Work Order ID 105228

Item Name: Crosstube Turning Detail

DART AEROSPACE LTD	Work Order:	105228
Description: Crosstube Assembly (412 High Aft)	Part Number:	D412-664-243
Inspection Dwg: D412-664-243 Rev: E		Page 1 of 2

DRAWING NO. D412-664-243	TITLE CROSSTUBE ASS'Y (412 HI AFT)	REV. E	DART AEROSPACE LTD ENGINEERING ORDER		D.E.O. NO. D412-664-243-E-2	SHEET NO. SHEET 1 OF 1	SCALE NTS
DRAWN <i>q</i>	CHECKED <i>AS</i>	MFG. APPR. <i>E</i>	APPROVED <i>MP</i>		DE APPR. <i>#</i>		
DATE 11.09.07	DATE 11.09.19	DATE 11.09.19	DATE 11.09.19		DATE 11.09.19

**D412-664-243
ASSEMBLY DETAIL**

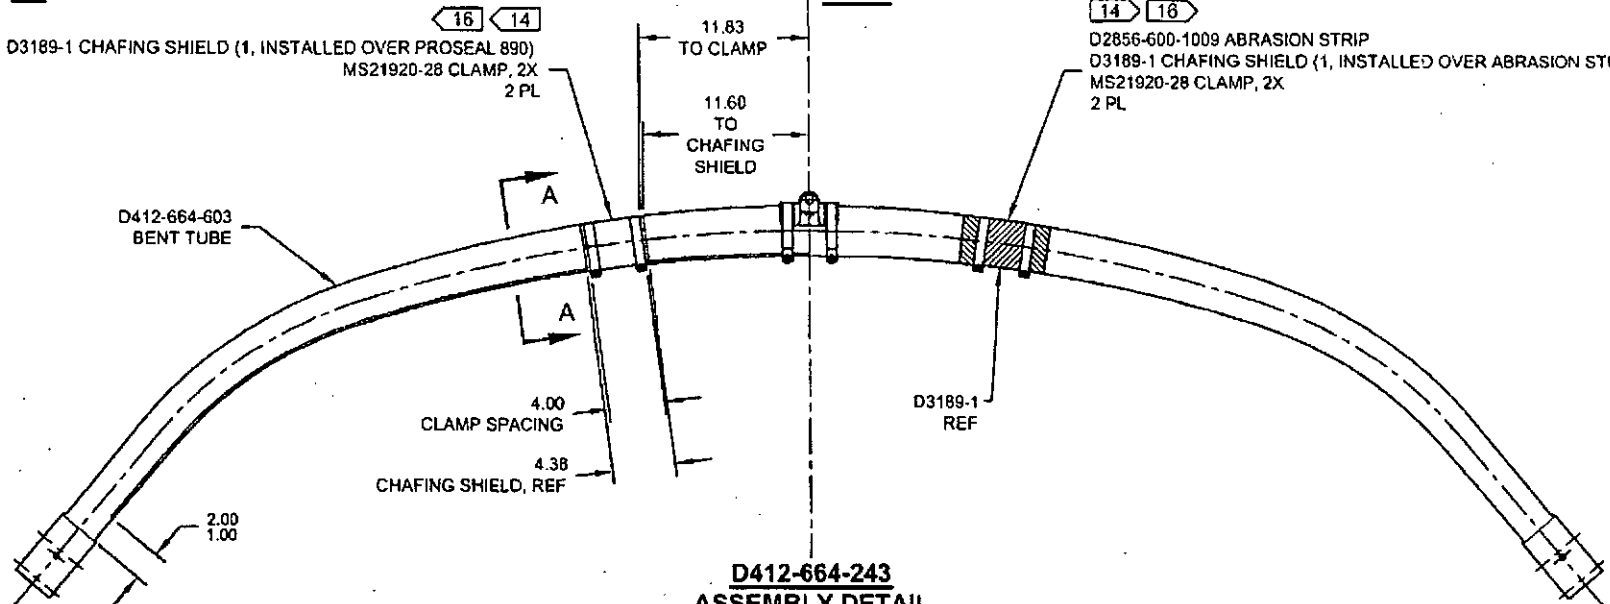
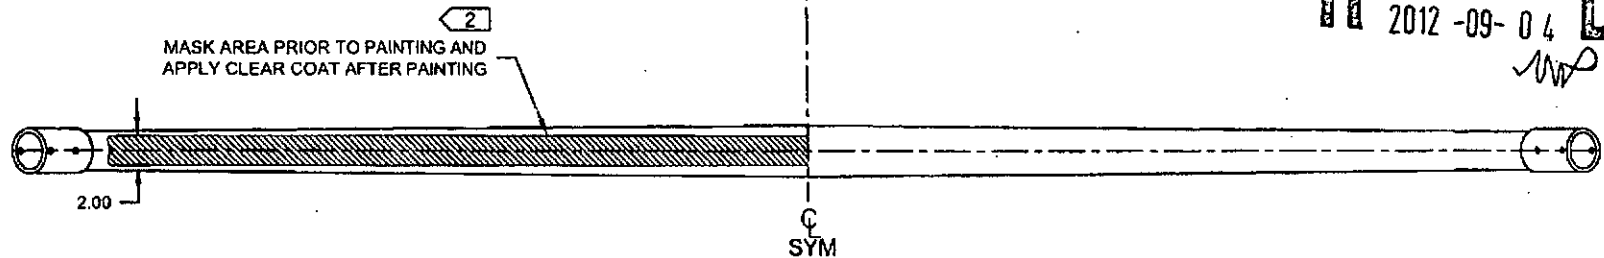
PURPOSE:

REMOVED ABRASION STRIP IN FAVOR OF A THIN LAYER OF PROSEAL 890. UPDATE INSTALLATION OF CHAFING SHIELDS AND REDUCE TORQUE TO 40-50 IN-LBS. THIS ENGINEERING ORDER SUPERCEDES DEO D412-664-243-E-1.

D3189-1 CHAFING SHIELD (1, INSTALLED OVER PROSEAL 890)
MS21920-28 CLAMP, 2X
2 PL
